Consultation on the proposed works to enable connection of the Eastern HVDC link and offshore wind generation at Branxton Substation

| Subject | Details |
|---------------------------|---------------------------------|
| Publication date: | 14 March 2022 |
| Team: | RIIO Electricity Transmission |

Figure 2: Branxton 400kV 21-bay option (proposed option) layout – single line diagram

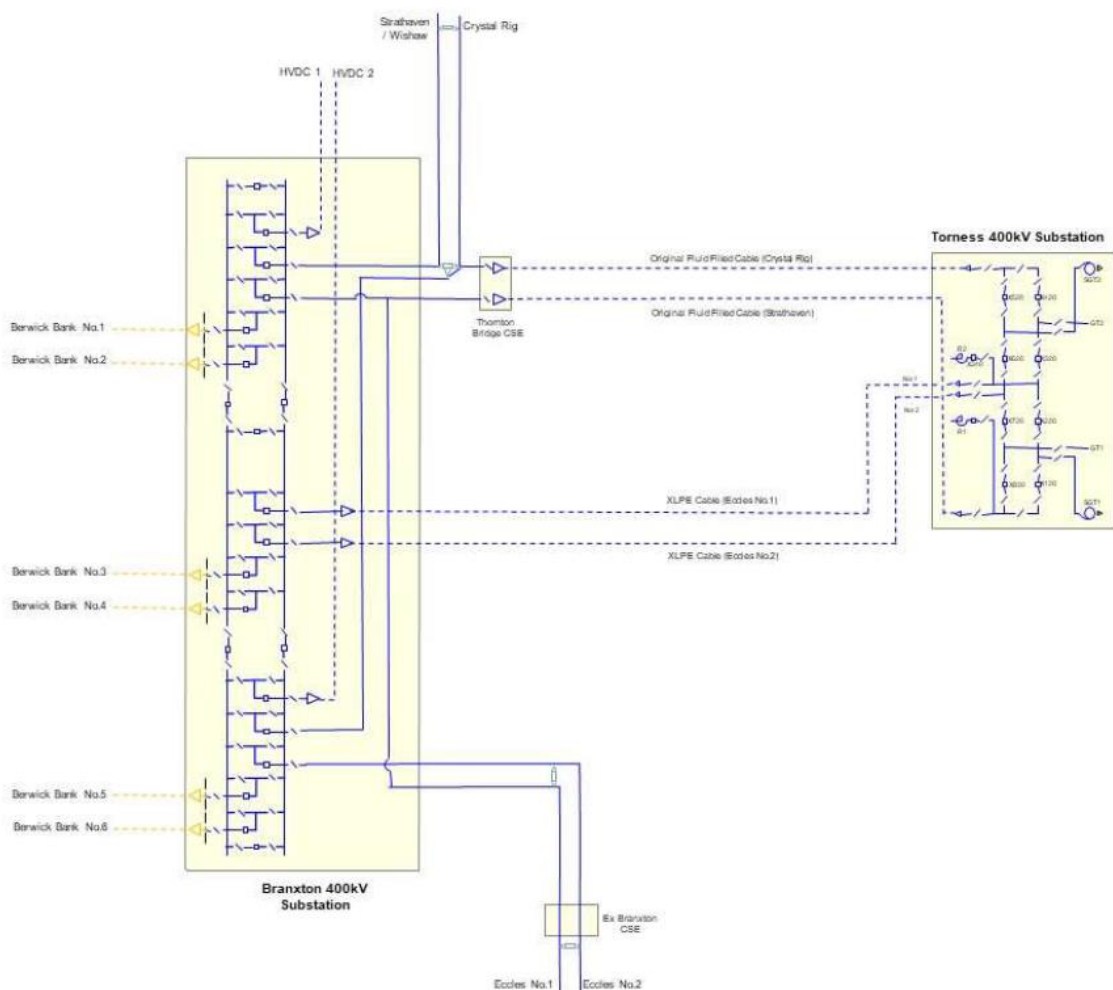
4.9. This option was selected because it minimises the risk of asset stranding at Branxton 400kV Substation and is in anticipation of the ultimate closure of Torness Power Station. The layout provides operational flexibility and security against an infeed loss above the NETS SQSS limit and accommodates future bays for the 2,300MW element of the wider Berwick Bank project. This option also mitigates the outage requirements necessary for future extension of the busbar system relative to the 23-bay and 14-bay configurations.

4.16. However, our minded-to view is that the construction of a new 21-bay GIS substation at Branxton and the subsequent substation works represents the optimal option.

5.8. Figure 2 below illustrates the layout of the preferred alternative. This option involves constructing a new 21-bay GIS substation with six bays for diverted circuits, four bus-sections and three bus-couplers, two bays for the connection of the Eastern HVDC Link and six future bays for the connection of the contracted 2,300MW Berwick Bank Offshore Wind Farm together with the connections to Torness 400kV Substation.
